**UNION VALE ZONING BOARD OF APPEALS**  
**Minutes of the Regular Meeting**  
**7:30 pm**

**June 1, 2021**

**Millbrook Inn, Owner Yvette Fromer, Applicant Jess Nahon, 3 Gifford Road, Millbrook, NY**

In order to make improvements to an existing inn in the RD-10 district: Applicant applying for area variances for a proposed parking lot, including area variances from the setback requirements set forth in the District Schedule of Area and Bulk Regulations, and Code Sections 210-56.E.8.h., 210-25.B.3; bundled within applications for variances under section 210-25.B.3 are requests for variances from the 25’ landscaped buffer requirement set forth in code section 210.37.C.2b. Applicant also applying for an area variance from the 85% minimum open space requirement set forth in the District Schedule of Area and Bulk Regulations.

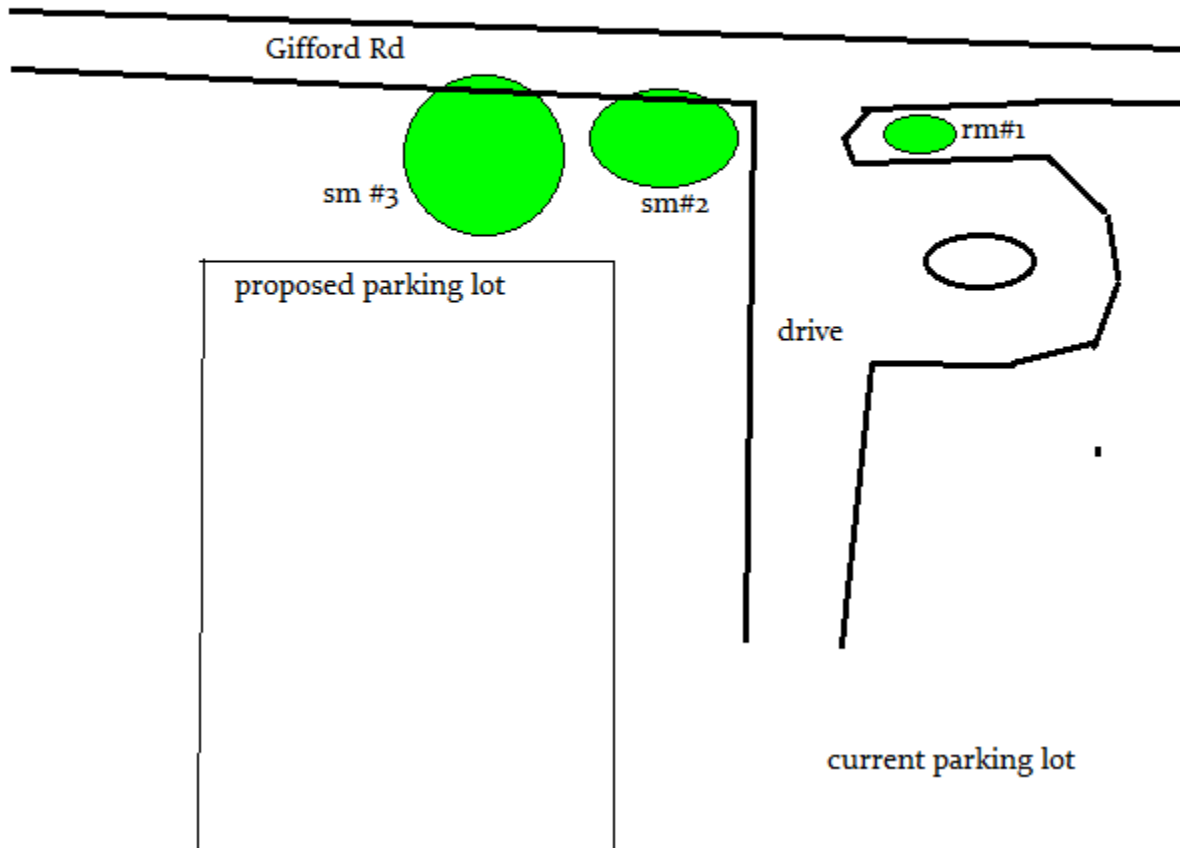
At our meeting we reviewed your plans to demolish the existing parking area for the Millbrook Inn and construct a new parking area as shown in the drawing on the next page. You had invited me to review the condition of and potential impacts on several trees surrounding the proposed parking lot area. The drawing on the next page shows the trees adjacent to the proposed parking lot, and their relative sizes, based on the size of the ellipses representing them. I have also numbered the trees to allow us to easily follow my comments and recommendations.

**Tree #1** (red maple *Acer rubrum*); ~12" DBH (diameter at 4.5' from the ground): This tree showed a large amount of the crown without leaves and dead. The lower trunk was buried, so no root flare was visible. This tree is in very poor condition and should be taken down and replaced as part of the renovation of the landscape around the Inn. This would be a great spot for a flowering ornamental tree, but sight distance should be considered in the tree's selection.

**Tree #2** (sugar maple *Acer saccharum*); ~22" DBH: This tree is in poor condition. It shows a main trunk that has fallen off in the past, and the wound has allowed a large amount of decay to enter the main trunk. There is evidence of splitting in the main trunk, where the two leaders come together. The tree's crown leans significantly toward the drive to the Inn, and shows a likely-hood of failure. The root system has been impacted by the excavation of the roadside drainage ditch along Gifford Rd, and shows some exposed roots. This tree should be taken down to eliminate a safety hazard to the Inn

**Tree #3** (sugar maple *Acer saccharum*); ~24" DBH: This tree is in fair condition and shows some decay in the upper main stem, from a branch break years ago. A number of dead limbs exist in the crown, which should be pruned out. The tree shows signs of large girdling roots on the east side of the trunk. This tree is in a condition that could be successfully brought through construction. To accomplish this, the tree should be individually measured to determine the exact DBH, and the CRZ should be measured and fenced off. This will keep construction vehicles off the CRZ to prevent soil compaction. To enhance tree health, pruning should be done prior to construction, and fertilization of the CRZ should be scheduled for the fall of 2021 and the fall of 2022. Communication within the construction management team is crucial here to preserve the CRZ area. If excavation has to occur within the CRZ, root pruning should occur to help limit root invasion by soil fungal diseases.
